January 27, 2022

Adam Mendez, Planner
Lee County Department of Community Development
1500 Monroe Street
Fort Myers, FL 33901

Reference: Williams Avenue CPD
DCI2021-00014 (2nd Resubmittal)

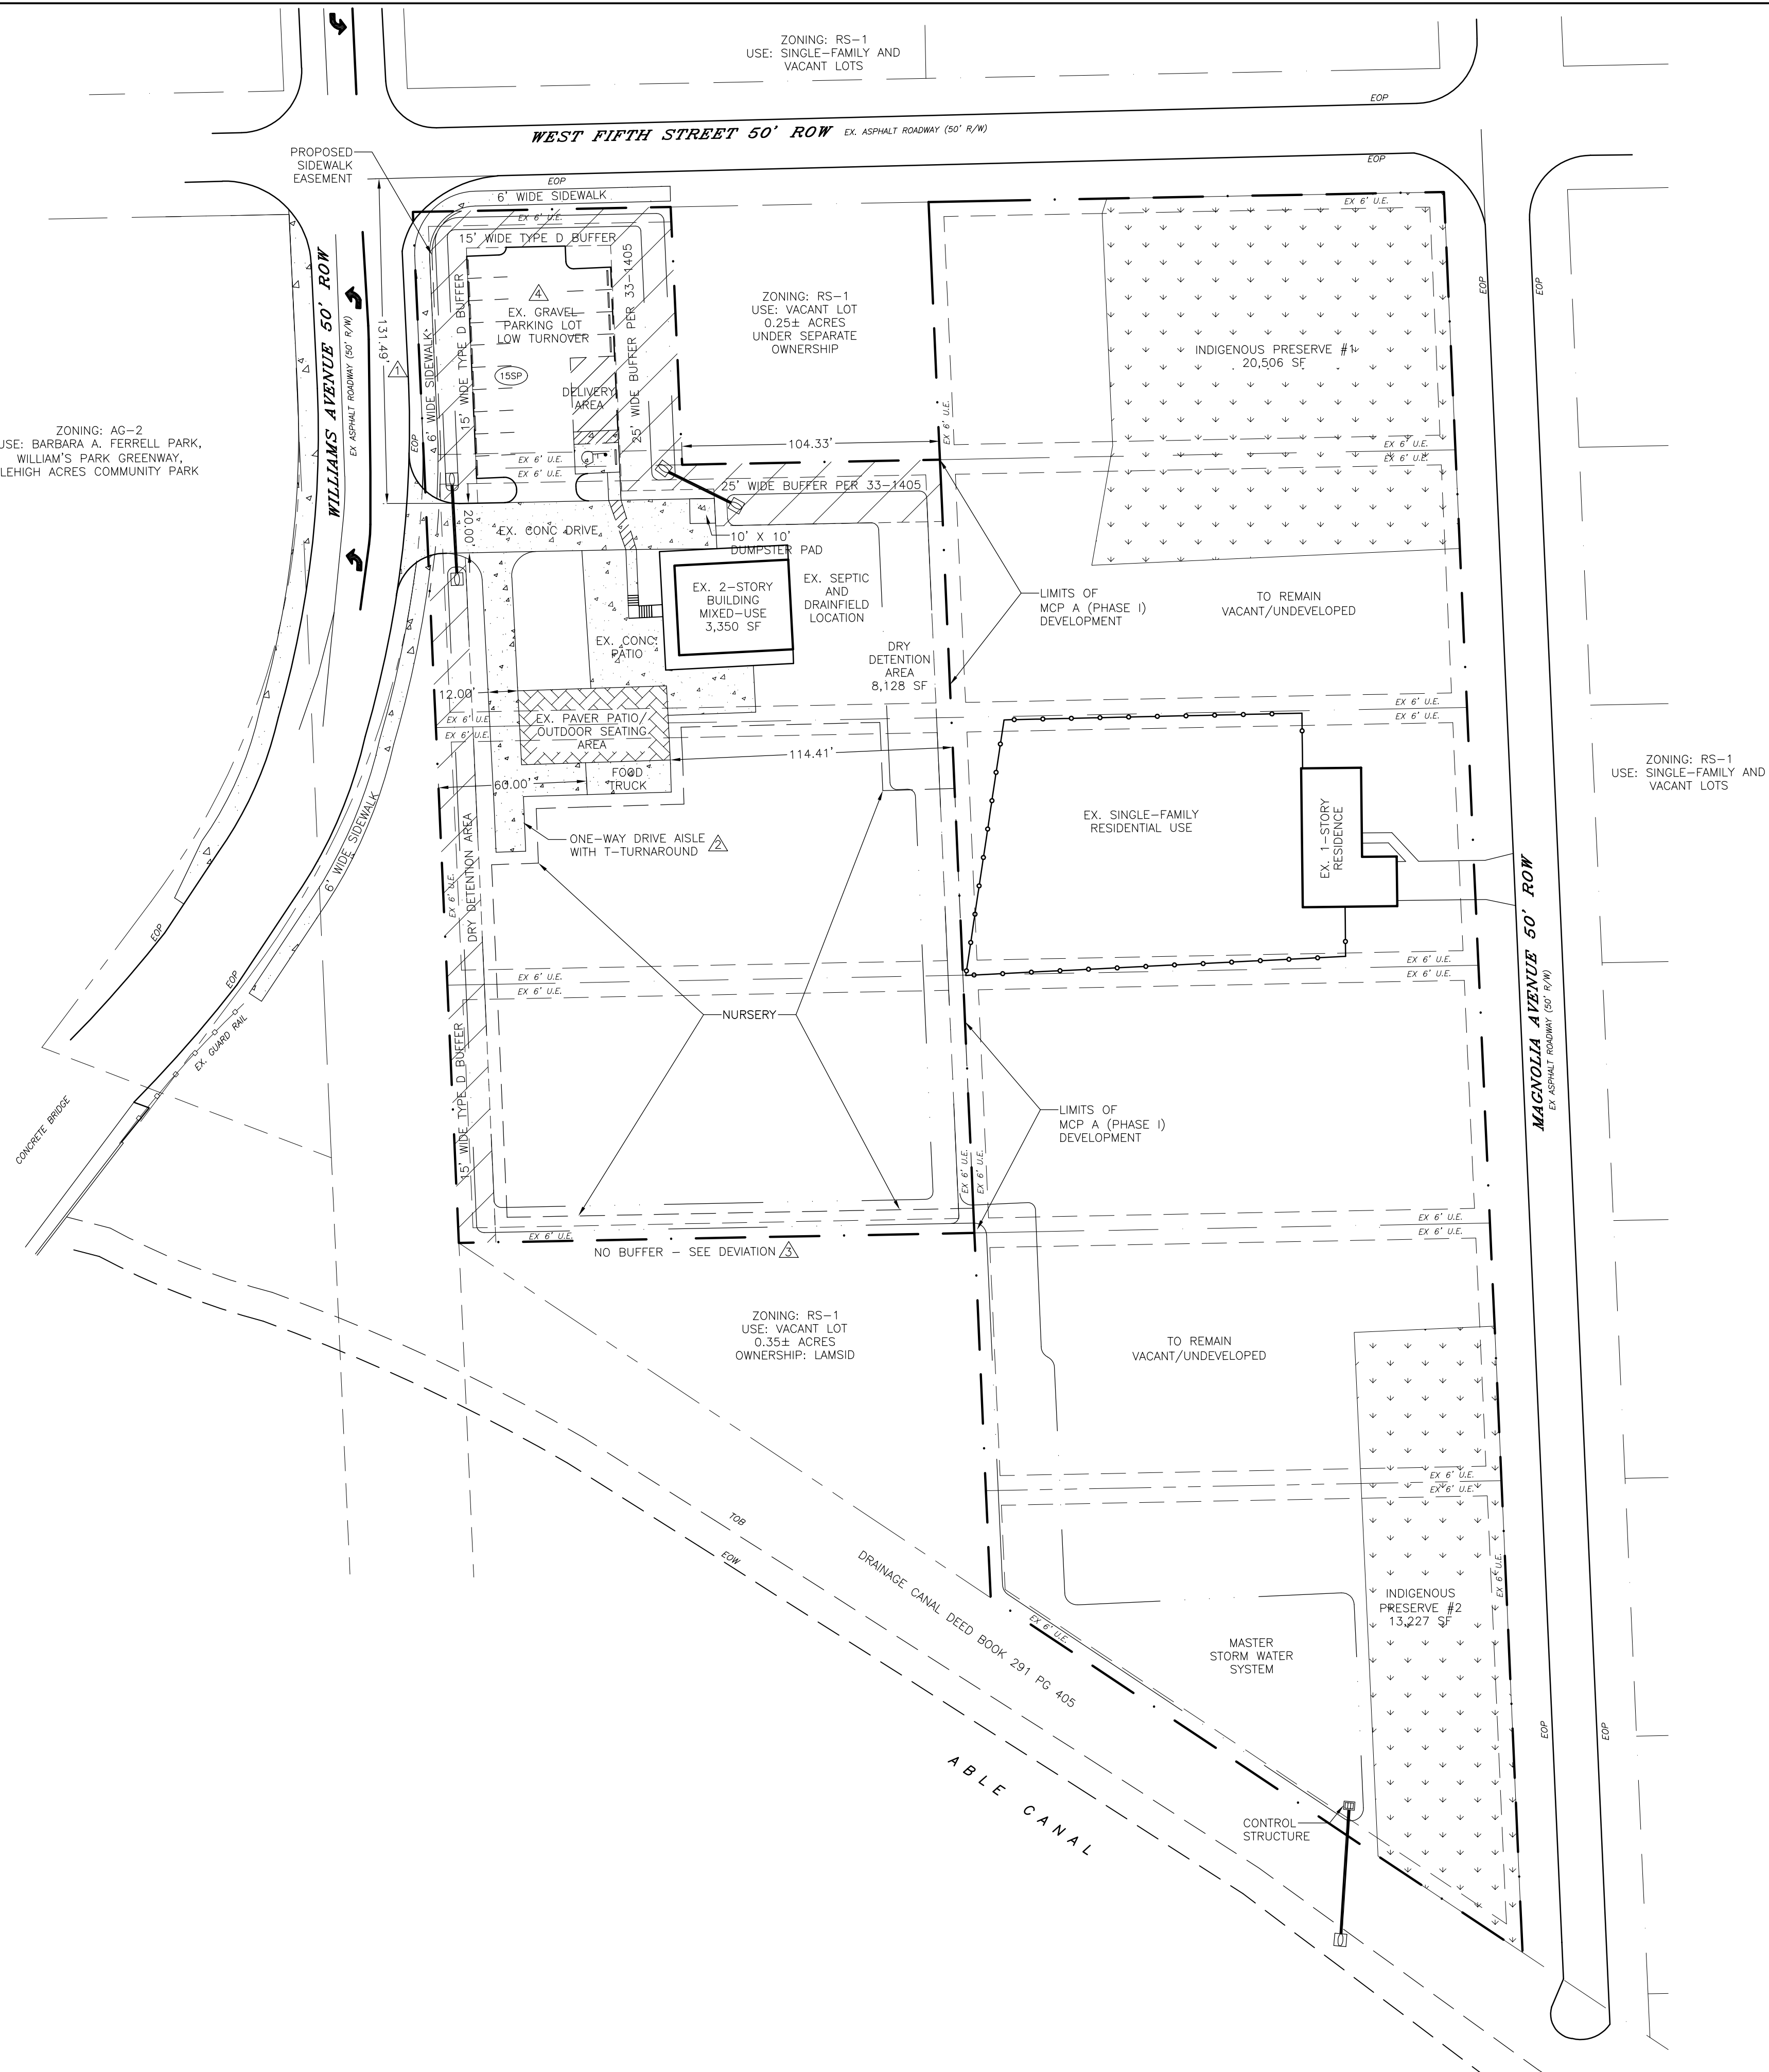
4. The applicant is requesting a deviation for a connection separation of 175’ for a right in/right-out to Williams Road. However, MCP option A shows an existing access point that doesn’t meet intersection separation requirements. Staff recommends the applicant include a deviation for this access to accommodate MCP option A. If a deviation is requested, please show the location on MCP option A.

5. MCP option A shows a drive aisle around the existing 2-story building. What surface is proposed for the drive aisle. There is not a matching shading in the legend.

6. MCP option A does not show an area reserved for garbage and recycling collection. Please indicate the area on the MCP.

9. Indicate on the MCP A what is planned for the portions of land not being developed. MCP A must depict the indigenous areas to support the overall CPD similar to the master stormwater system that is depicted.

Response: Please see the revised Schedule of Deviations and MCP A – Option I for the information requested.

Response: Please note the drive aisle has been removed from MCP A since there is an existing septic and drain field at that location. Please see the revised MCP A.

Response: Please see the revised MCP A for the dumpster location as requested.

Response: Please see the revised MCP A for the information requested.

EXHIBIT 2
 TRAFFIC IMPACT STATEMENT – MCP A
 PEAK HOUR TRAFFIC DISTRIBUTION
 416 WILLIAMS AVENUE,
 LEHIGH ACRES, FL, 33972

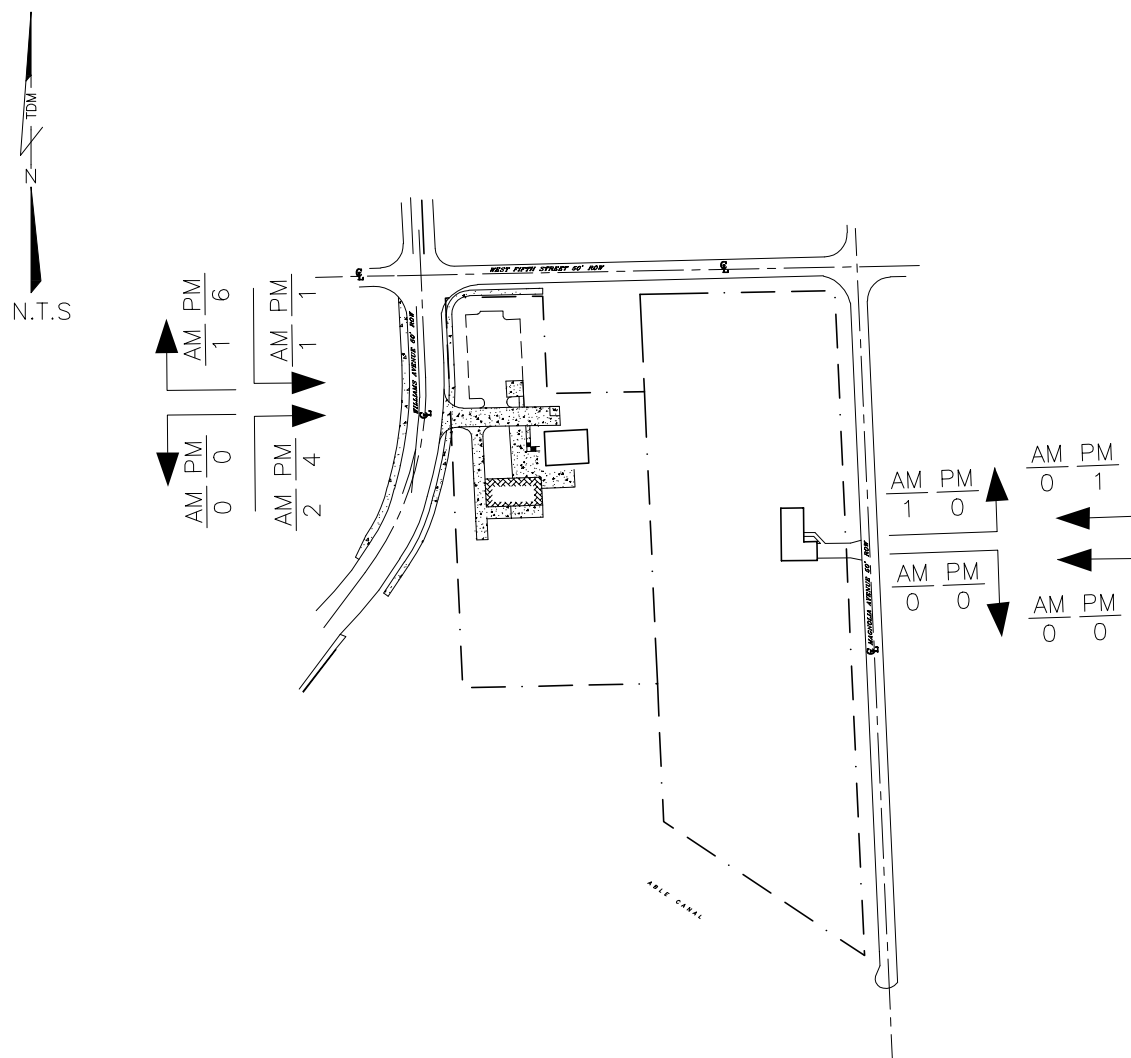
14. DOT Comment: Please note Lee County DOT will only support right-in only access on Williams Ave (no right-out).

Response: This comment is acknowledged; however, our Traffic Engineer disagrees with staff's opinion. The applicant will continue to propose a right-in/right-out driveway on Williams Avenue for MCP B and a full access driveway for MCP A.
